Value Engineering Study

***EAST NICHOLASVILLE BYPASS
JESSAMINE COUNTY, KENTUCKY***

ITEM NUMBER 7-87.01

Study Date: July 19 - 23, 2010
Draft Report Date: July 30, 2010

VALUE ENGINEERING RECOMMENDATION # VE-19d

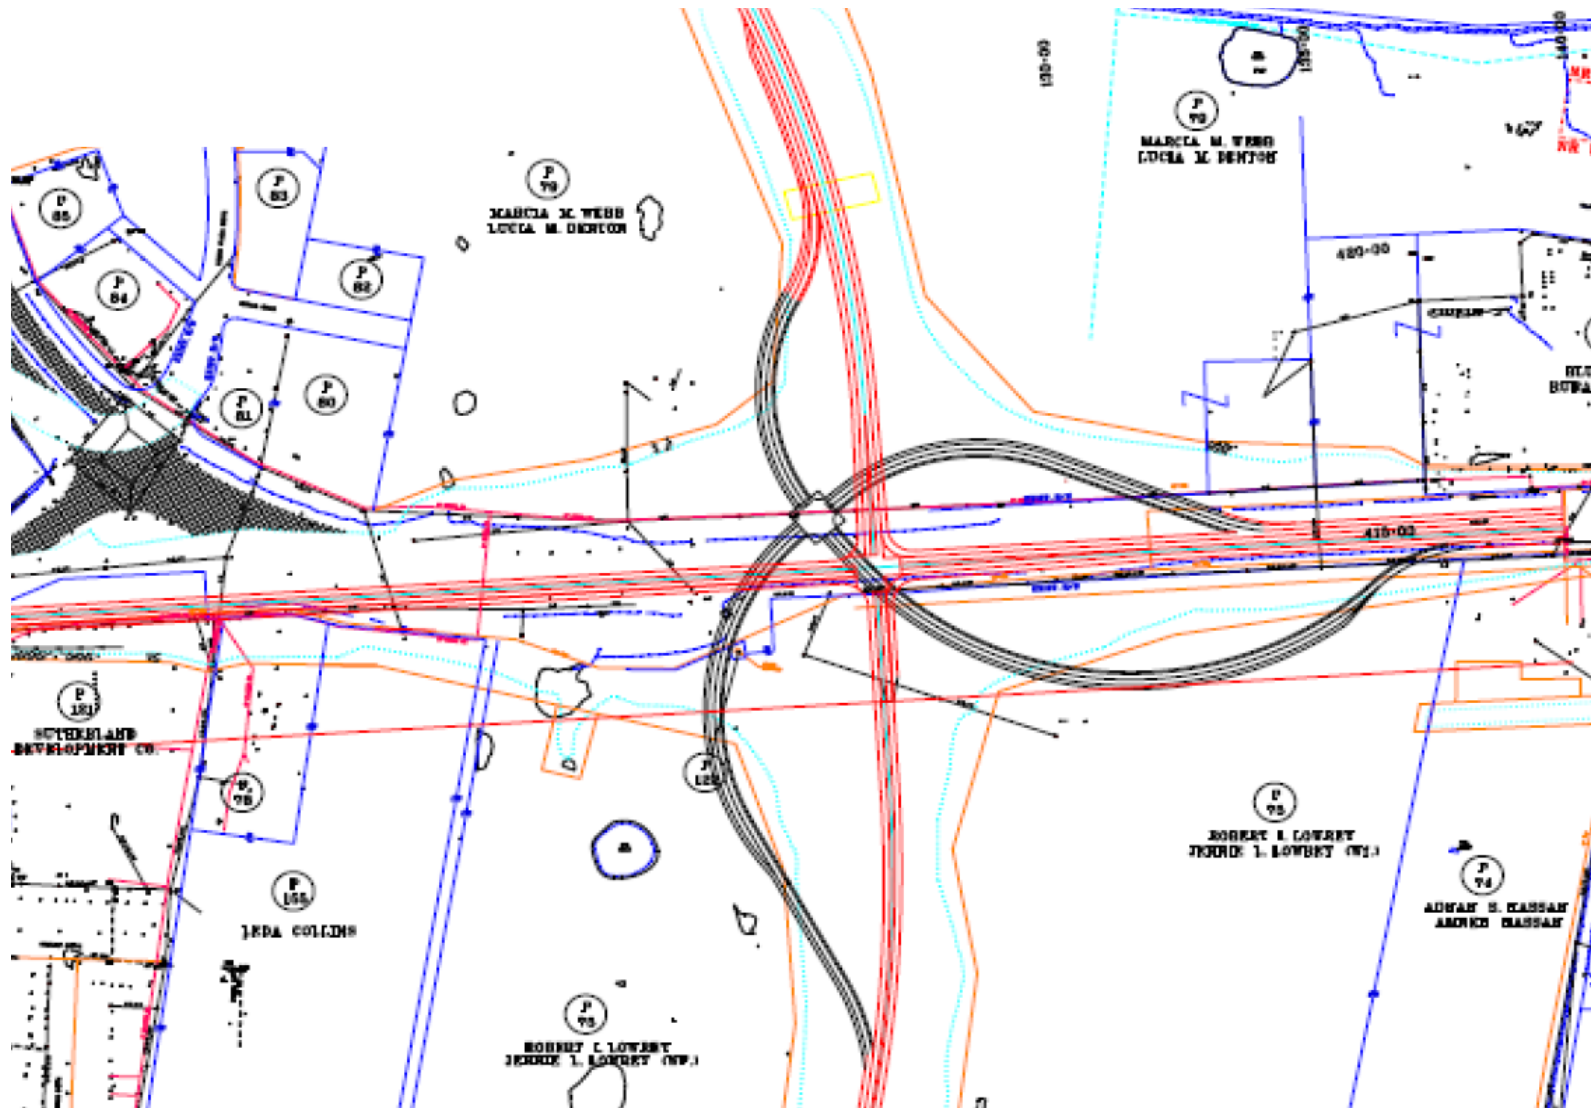
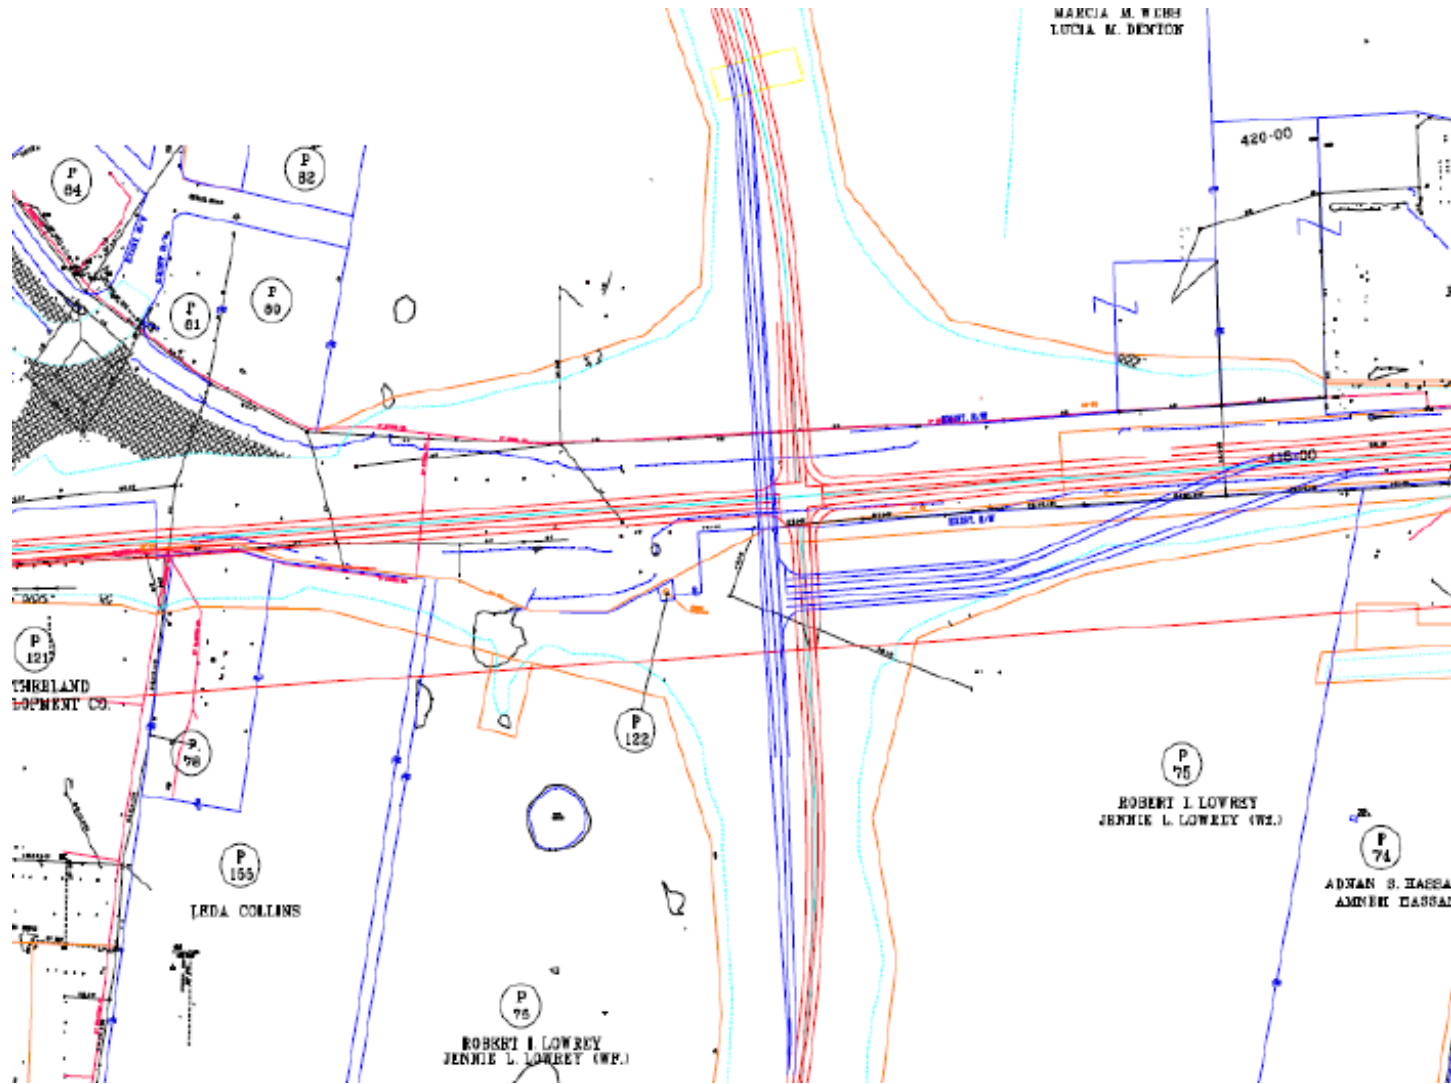
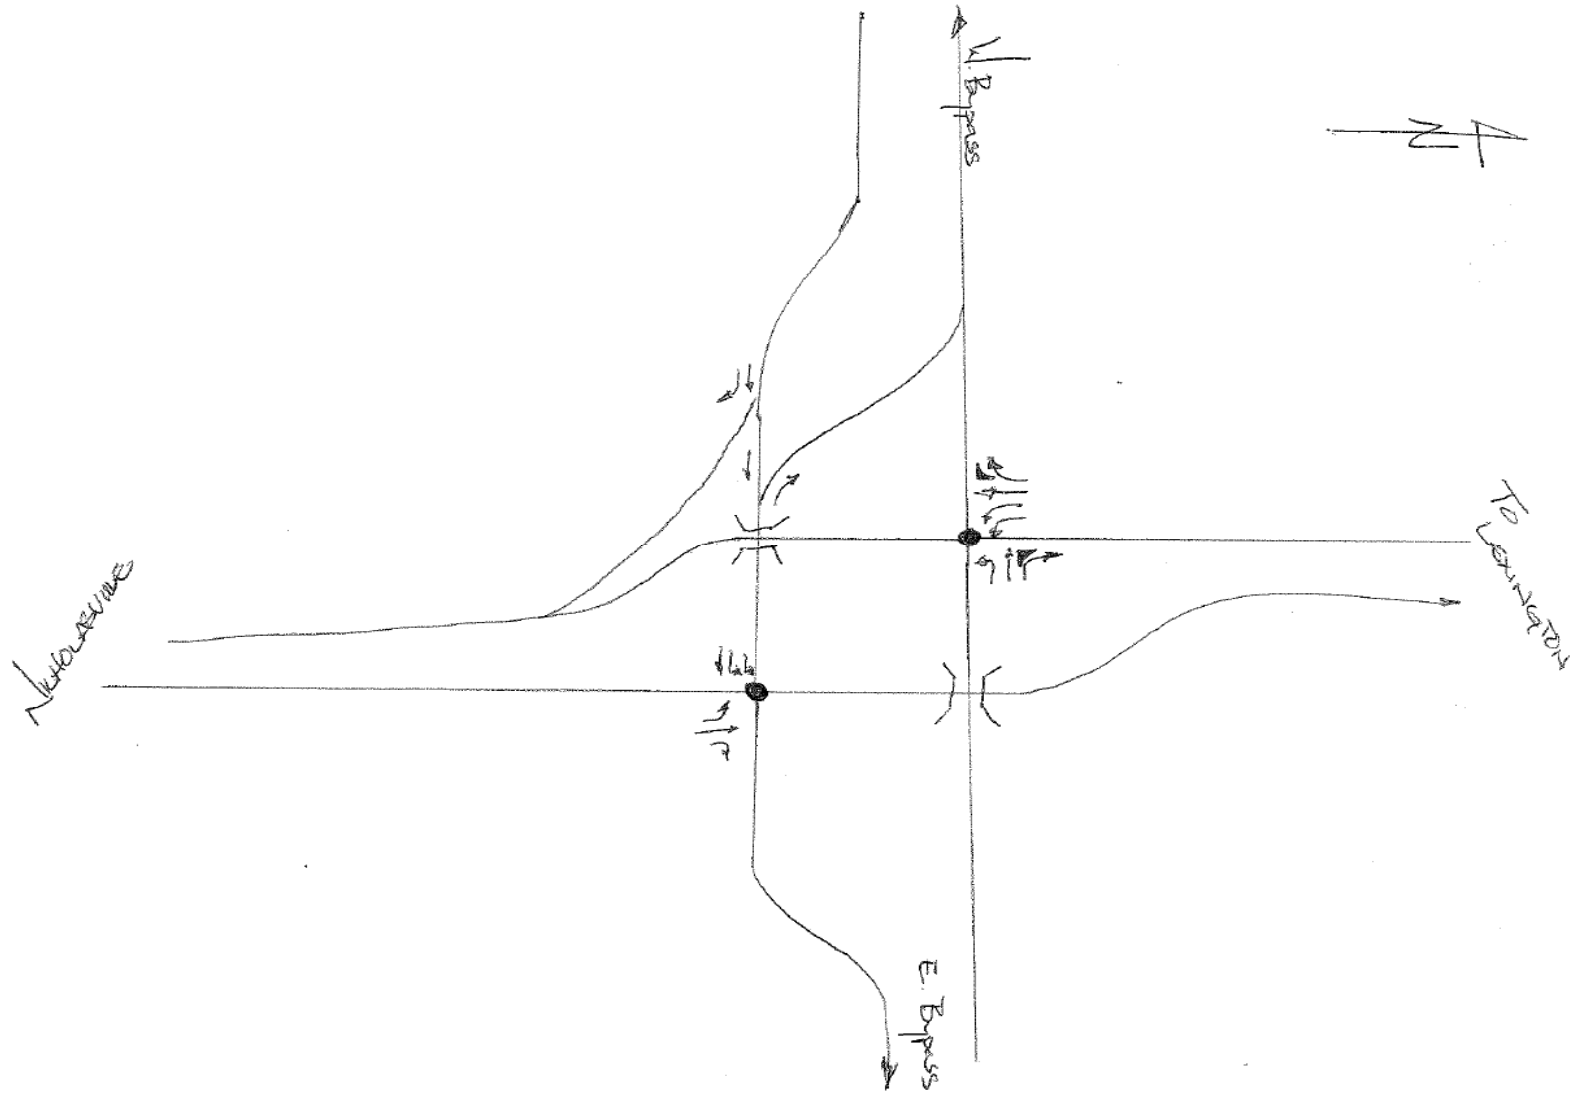
VE-19d	Utilize KIRK Intersection Design (KID) (at-grade intersection with two intersecting left-turn fly-over ramps) in lieu of SPUI	\$5,403,000		\$5,403,000	X

KID Interchange - Option 1

KID Interchange - Option 2

KID Interchange - Option 3
